Your Comment on the Maitahi Village Extension application

Reply to Applicants Reply to Fast Track Mahitahi Development Application

Directly Affected Adjacent Residents Submission

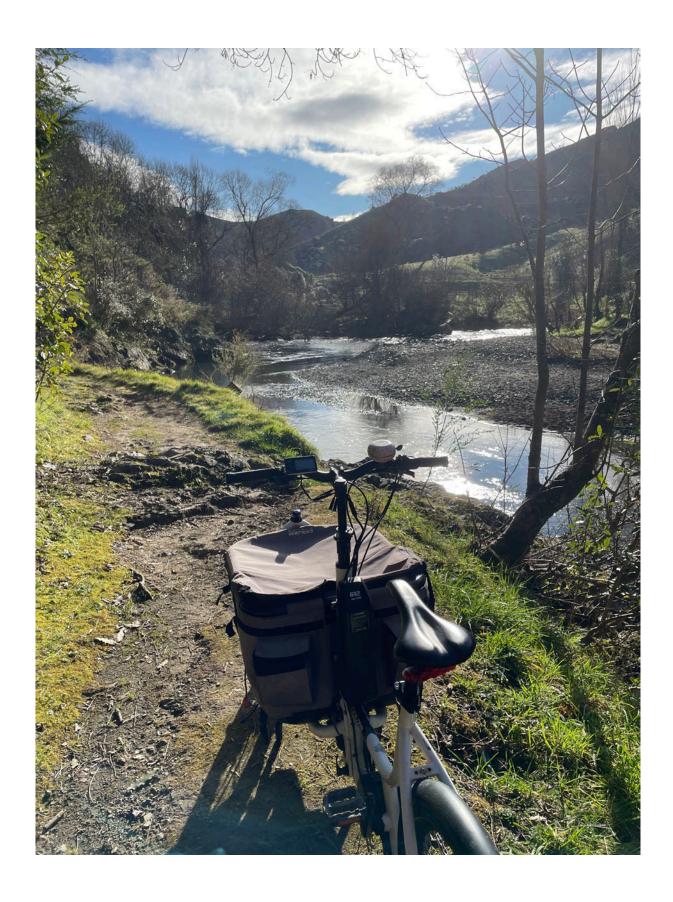
The Dennes Hole route has never flooded and is 3m above river levels at the lowest point - See below:

In the 30 years since we have lived in the area, this area has never flooded, it is simply untrue to say that it is at risk of flooding (Note tape is bent but is measuring 3400 which gives the 3m heigh above river level). We are asking for it to be properly formed 2m wide.
